**CHANGE
ORDER**

PROJECT:	Washoe County – Nevada Shared Radio System	CHANGE ORDER NO.:	8
		DATE:	09/22/2020
SELLER:	Harris Corporation Communication Systems Segment	CONTRACT DATE:	September 27, 2018
SELLER ADDRESS:	221 Jefferson Ridge Parkway Lynchburg, VA 24501

Change Order No. 8 Detailed Description

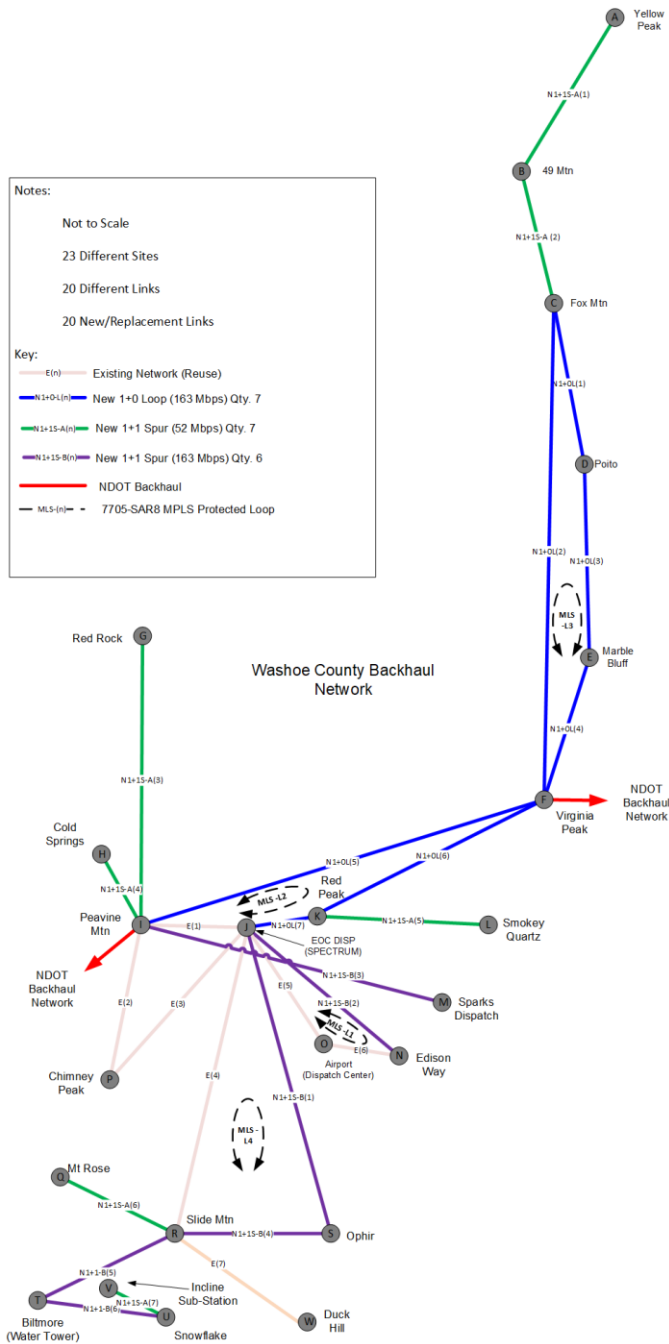
Harris will design and implement the new Washoe County microwave network that will provide high-speed wireless Ethernet transmission via the Nokia 7705 SAR-8 MPLS router installed at each Washoe County site. The new Washoe County microwave network will interconnect with the NDOT microwave network to form the NSRS backhaul. Harris will perform all services to implement all new equipment that includes microwave dishes, waveguide, radios, dehydrators, Network Management System and MPLS routers to provide network connectivity between the RF sites, cores, and existing PSAPs in Washoe County. Harris has reviewed the existing Comsearch Microwave Path Data Sheet provided by Washoe County and have used this data along with the selected RF sites in Washoe County to provide a microwave backhaul network solution that will interconnect to the NDOT microwave network which forms the NSRS. The new Washoe County microwave network solution comprises of 20 links which is a combination of loop-protected microwave links and monitor hot standby (MHSB) links. These links will interconnect the cores, RF sites and PSAPs to the NSRS. Each link will be designed with a path availability of 99.999% based on the receive threshold to provide the required link bandwidth.

Included in Nokia Quote	Designation	Site A Name	Site B Name	Bandwidth Proposed	Bandwidth New Request
No	E(1)	Spectrum (EOC_DISP)	Peavine Mtn	Existing	Existing
No	E(2)	Peavine Mtn	Chimney Peak	Existing	Existing
No	E(3)	Spectrum (EOC_DISP)	Chimney Peak	Existing	Existing
No	E(4)	Spectrum (EOC_DISP)	Slide Mtn	Existing	Existing
No	E(5)	Airport (DispCnt)	Spectrum (EOC_DISP)	Existing	Existing
No	E(6)	Edison Way	Airport (DispCnt)	Existing	Existing
No	E(7)	Slide Mtn	Duck Hill	Existing	Existing

Included in Nokia Quote	Designation	Site A Name	Site B Name	Bandwidth Proposed	Bandwidth New Request
Yes	N1+0L(1)	Poito	Fox Mtn	25	163
Yes	N1+0L(2)	Virginia Peak	Fox Mtn	25	163
Yes	N1+0L(3)	Poito	Marble Bluff	25	163
Yes	N1+0L(4)	Virginia Peak	Marble Bluff	25	163
Yes	N1+0L(5)	Peavine Mtn	Virginia Peak	166	163
Yes	N1+0L(6)	Virginia Peak	Red Peak	166	163
Yes	N1+0L(7)	Spectrum	Red Peak	166	163
Yes	N1+1S-A(1)	49 Mtn	Yellow Peak	25	52
Yes	N1+1S-A(2)	Fox Mtn	49 Mtn	25	52
Yes	N1+1S-A(3)	Red Rock	Peavine Mtn	Not proposed	52
Yes	N1+1S-A(4)	Peavine Mtn	Cold Springs	25	52
Yes	N1+1S-A(5)	Red Peak	Smokey Quartz	52	163
Yes	N1+1S-A(6)	Mt Rose	Slide Mtn	25	52
Yes	N1+1S-A(7)	Snowflake	Incline	25	52
Yes	N1+1S-B(1)	Spectrum	Ophir Peak	Not proposed	163
Yes	N1+1S-B(1)	Peavine Mtn	Sparks Dispatch	25	163
Yes	N1+1S-B(2)	Edison Way	Spectrum (EOC_DISP)	Not proposed	163
Yes	N1+1S-B(4)	Slide Mtn	Ophir Peak	166	163
Yes	N1+1S-B(5)	Biltmore	Slide Mtn	25	163

Yes	N1+1S-B(6)	Snowflake	Biltmore	25	163

The new Washoe County microwave network will include the Nokia 7705 SAR-8 MPLS routers for routing all packets between microwave sites, core locations and between NDOT and Washoe County microwave networks. In the event of a microwave path failure within a microwave loop, the 7705 SAR-8 will automatically reroute traffic to the opposite direction of the network. For RF sites that are connected by microwave spurs, a 1+1 MHSB radio will be installed to increase the reliability of the link. Harris has designed the microwave network based on the topology provided in Figure 23 below. The main microwave loop for interconnecting the two core sites in Washoe County consists of a 163 Mbps 1+1MHSB link with 7705 SAR08 MPLS backup loop protection using available bandwidth of existing links. The two cores are located at the EOC Dispatch and Edison Way locations. The northern loop and all spur sites will have links that support 52 Mbps radios. The Washoe County microwave network will interconnect with the NDOT microwave solution which share network nodes at Peavine Mtn and Virginia Peak site locations. Harris will coordinate with NDOT to support the routing of packets between the cores, RF sites and PSAPs located on the Washoe County side and the NDOT side of the NSRS.

The existing microwave links in Washoe County were considered and are based mainly on Nokia (formerly Alcatel) DS1 microwave circuits. Analysis of the existing microwave paths that will be reused are limited in bandwidth due to the nature of the existing DS1 signaling and will need to be replaced with all new Ethernet based radios to meet the NSRS bandwidth requirements. The existing DS1 links will remain operational until full cutover to the new NSRS. At that point, the equipment for ten existing links that are being replaced will be removed only.
